RE: Final Conditional Approval
S & S Mining Company
Red Rock Mine
ACT/037/050
San Juan County, Utah

Diversion Ditch Design

S & S Mining Company
Red Rock Mine
ACT/037/050
San Juan County, Utah

FIGURE 1
Rainfall Amounts by Geographical
Region - 25-Year, 24-Hour Storm

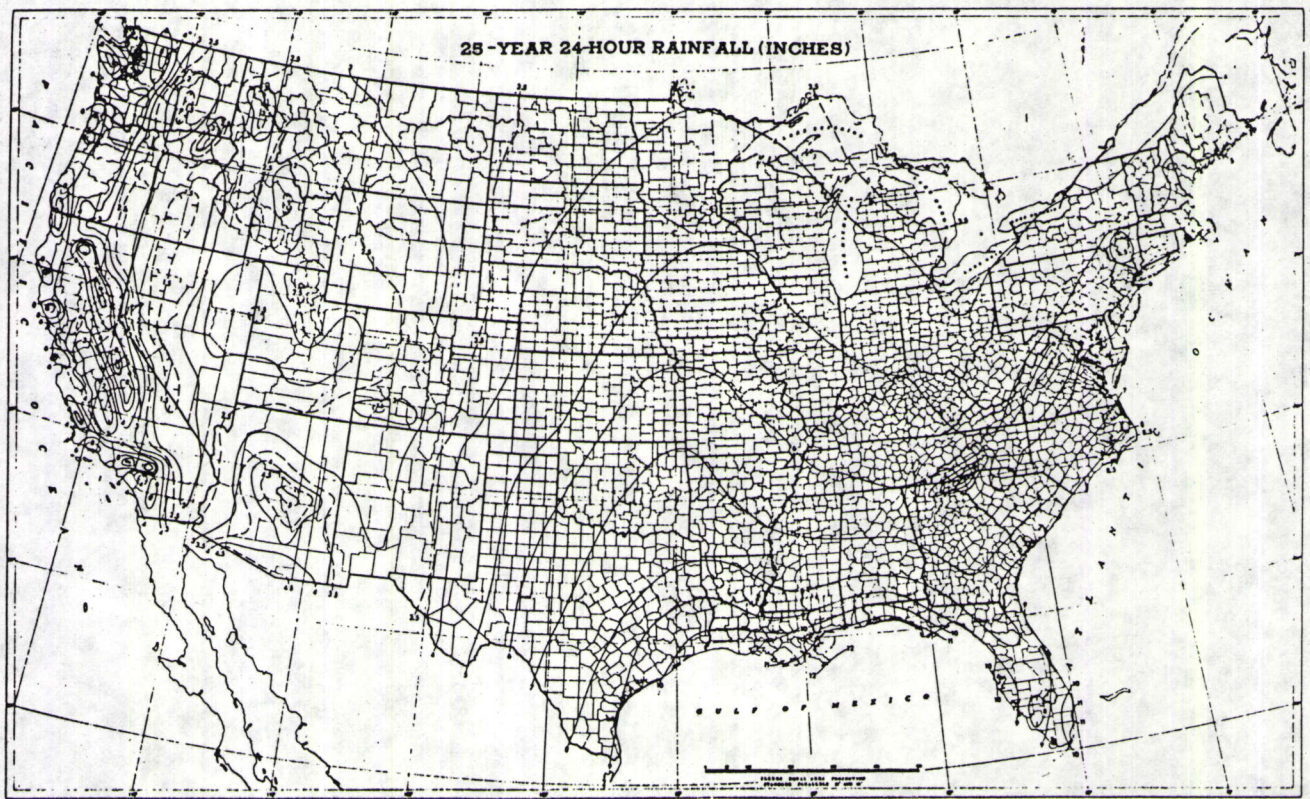
*Intensity based
on time of
concentration (tc),
not Rainfall inches (storm)
precip
divided by storm duration
(hours) !!*
